Date: Sept 11, 1998

To: T10 Committee (SCSI)

From: George Penokie (IBM)

Subject: Persistent Reservations

Figure 1 — Device server interpretation of PREEMPT service action

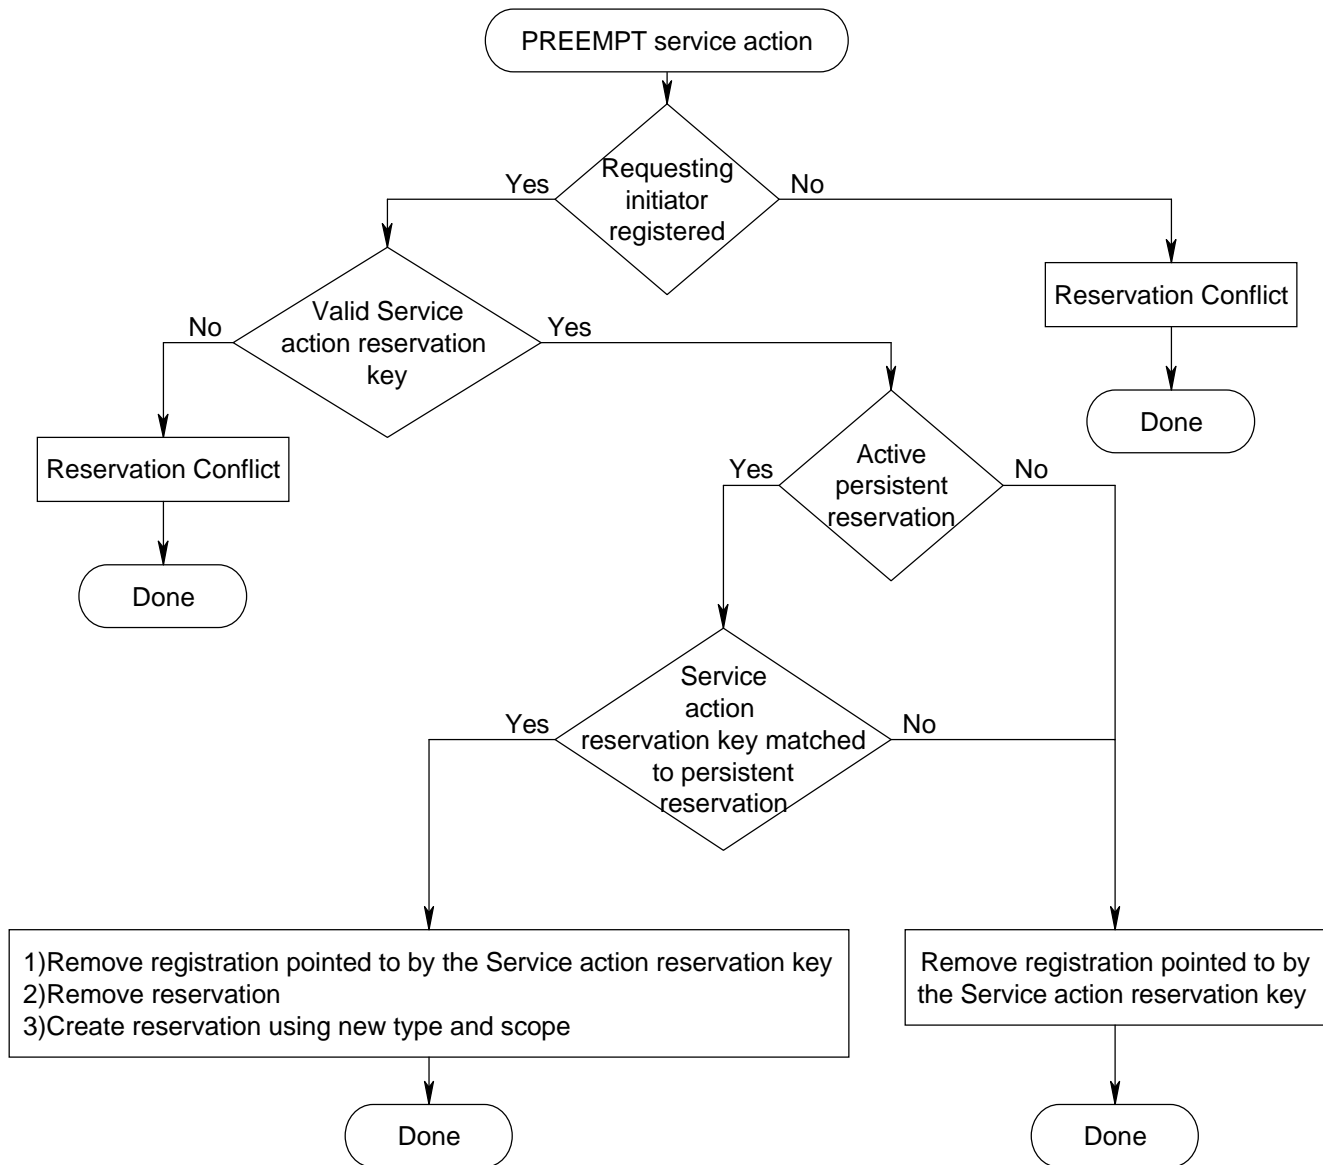
A PERSISTENT RESERVE OUT command with a PREEMPT service action is used to preempt a persistent reservation and/or registration. See figure 1 for a description of how a device server should interpret a PREEMPT service action to determine the actions it should take (i.e., preempt persistent reservation, preempt registration or preempt both registration and persistent reservation).
